**Explanation of Significant Differences  
Operable Unit 2 Record of Decision**

Former Naval Weapons Industrial Reserve Plant

Bethpage, New York

September 2021

DRAWN BY	DATE	CTO
MC	01/25/21	N62470-16-D-9008-WE16
CHECKED BY	DATE	FIGURE NUMBER
DB	01/25/21	5

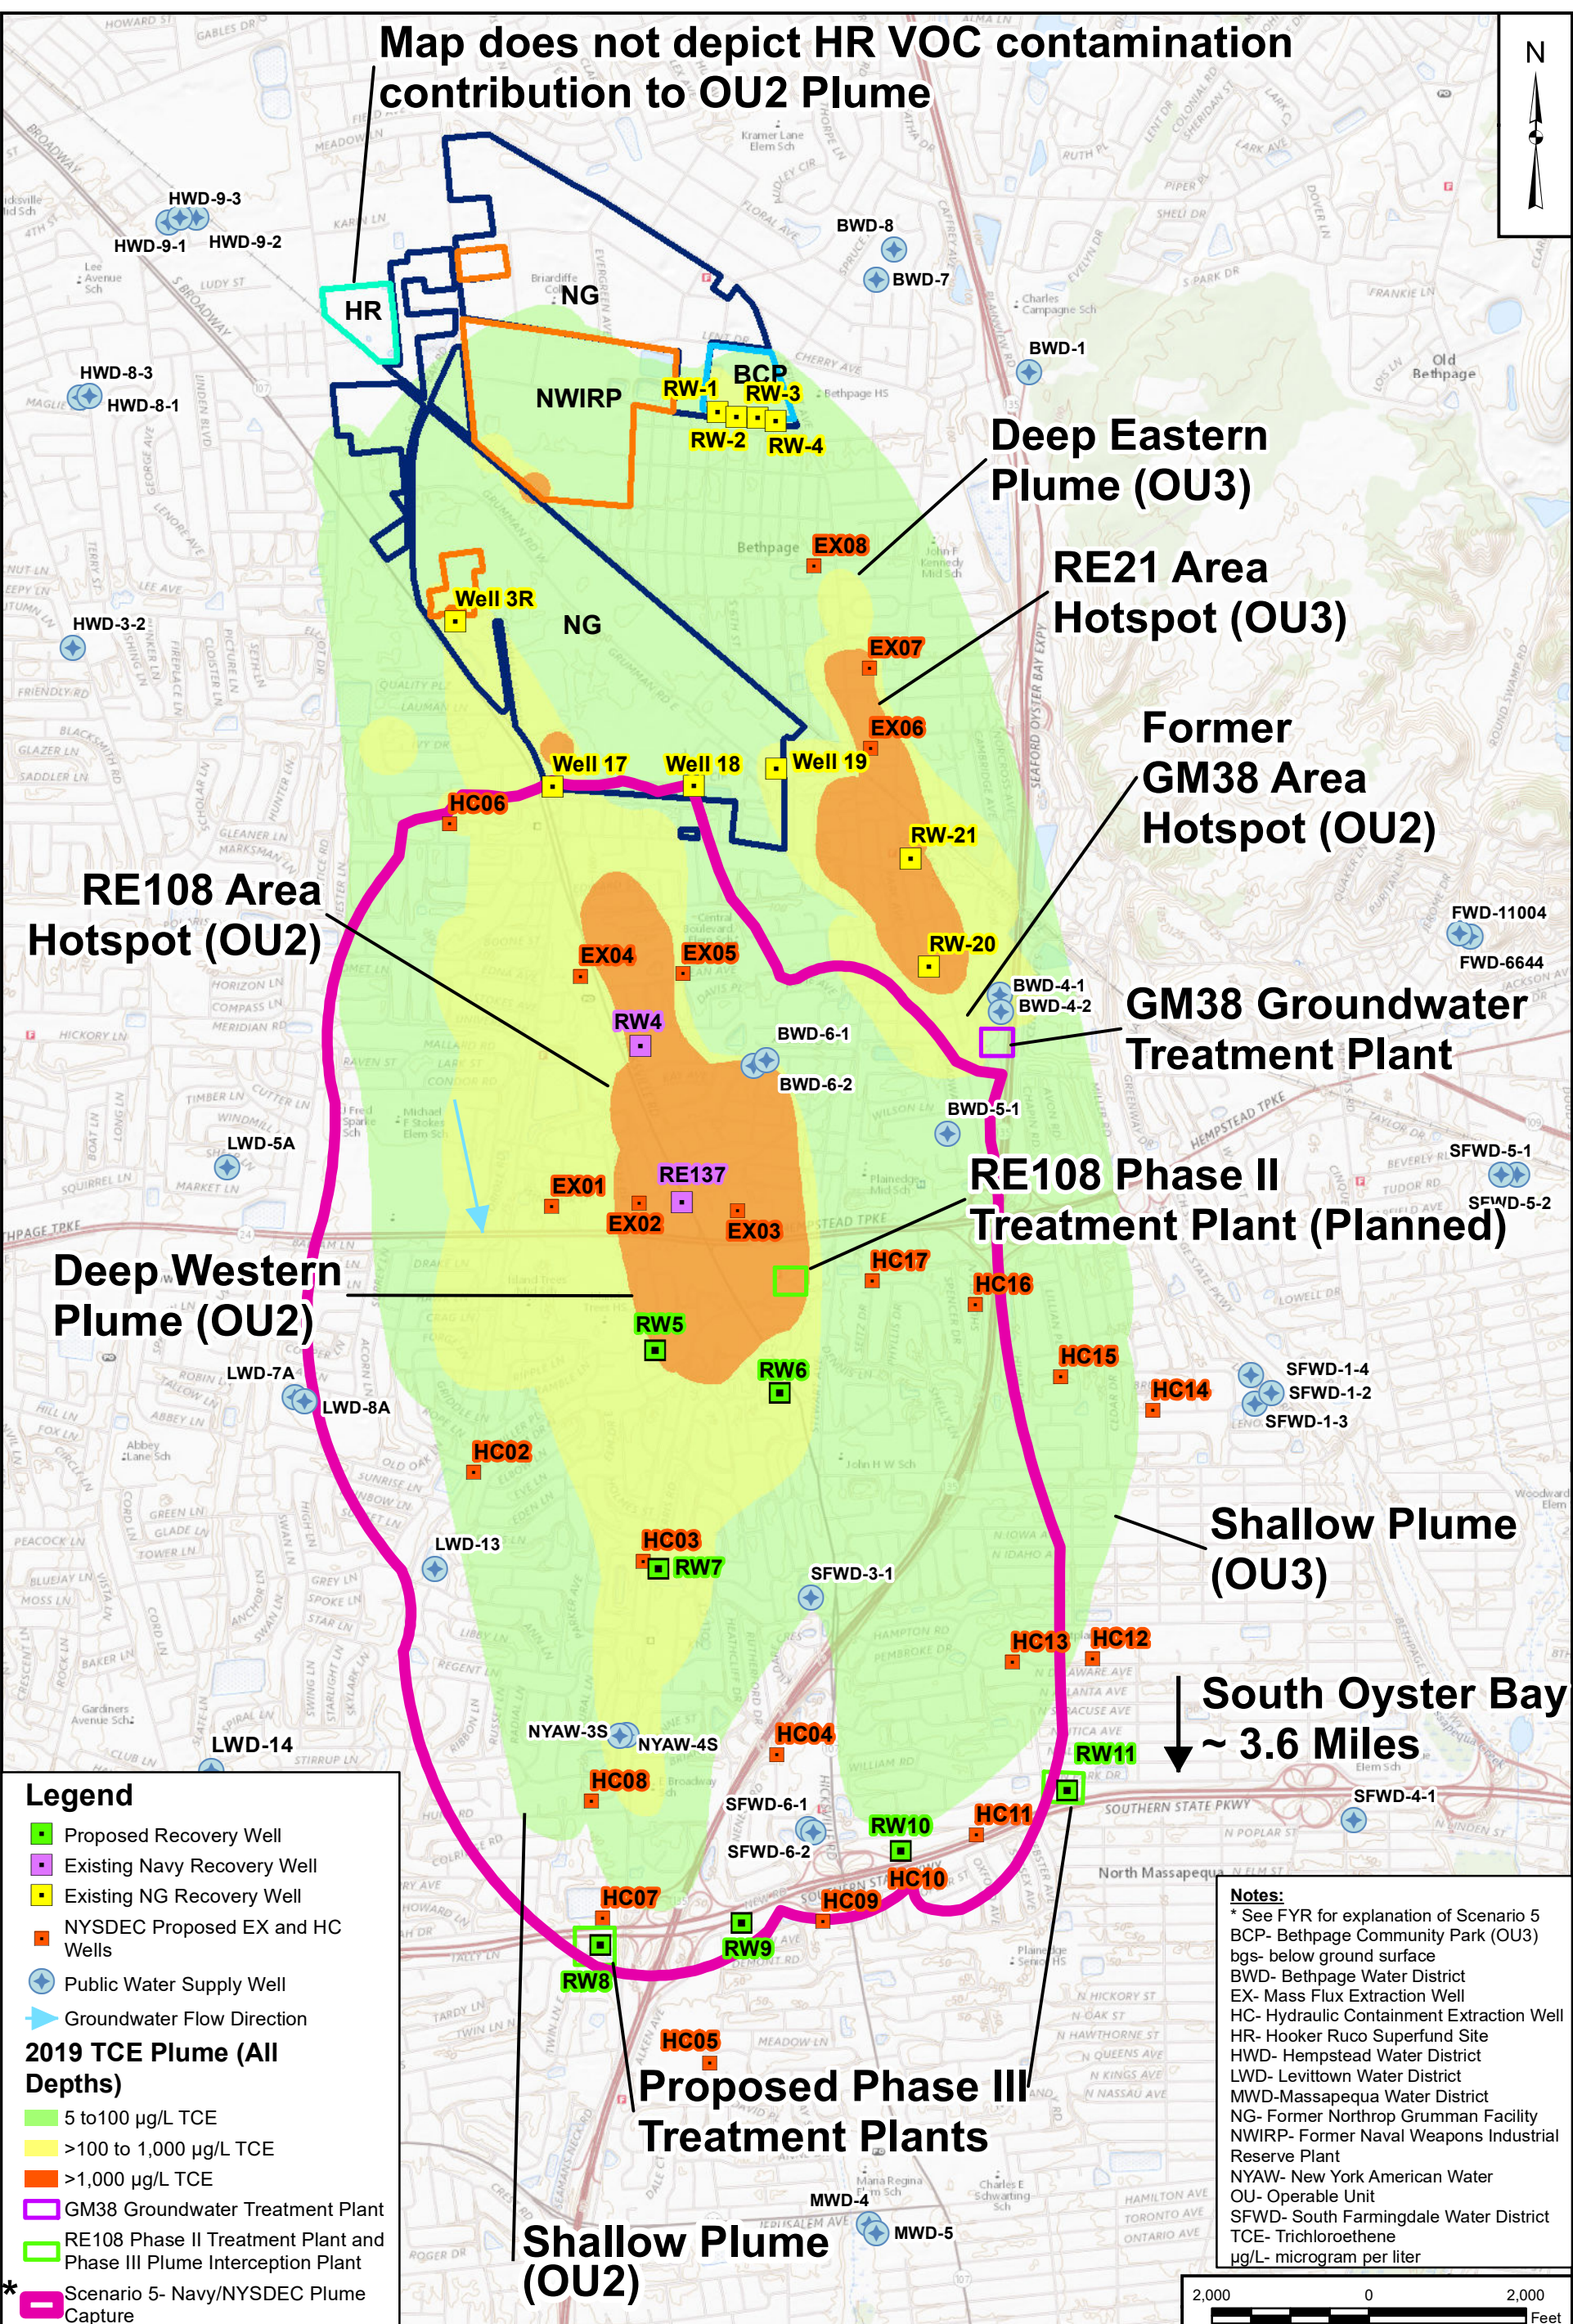
The RE108 Phase II Treatment System Extension (Phase II Extension) includes the addition of two recovery wells (RW7A and RW7B collectively shown as RW7 on Figure 5) to address chlorinated VOC contamination in excess of 150 µg/L, south of the planned RE108 Phase II Treatment System. Groundwater extracted by RW7 will be piped to the Phase II Treatment System. The 1,4-dioxane concentration in RW7, prior to treatment, is expected to be 5 µg/L. The Phase II Treatment System is being designed to address 1,4-dioxane to comply with the recently promulgated NYSDOH MCL, as well as to treat chlorinated VOC contamination, by including AOP in the planned treatment system.

In order to intercept the OU2 plumes at their southern extent, the Navy plans to install up to four additional groundwater recovery wells (RW8 through RW11 on Figure 5) and one to two additional treatment facilities to the south (downgradient) of the RE108 Area

Current preliminary groundwater flow modeling indicates that four new recovery wells (RW8, RW9, RW10, and RW11 on Figure 5) will intercept and control the migration of the deep western and shallow eastern portions of the OU2 plumes, as practicable. The Phase III PDI will be used to determine if recovery well pairs similar to Phase II RWs, are necessary to maximize plume capture.

Preliminary Phase III System recovery well locations are provided in Figure 5. Also shown on this figure are the extraction wells necessary for implementation of the Selected Remedy as presented in the NYSDEC AROD (NYSDEC, 2019). Based on close proximity, the Navy recovery wells identified in this ESD would reduce or eliminate the need for some of the NYSDEC proposed extraction wells in the area, including HC07, HC09, HC10, and HC11 (Figure 5).
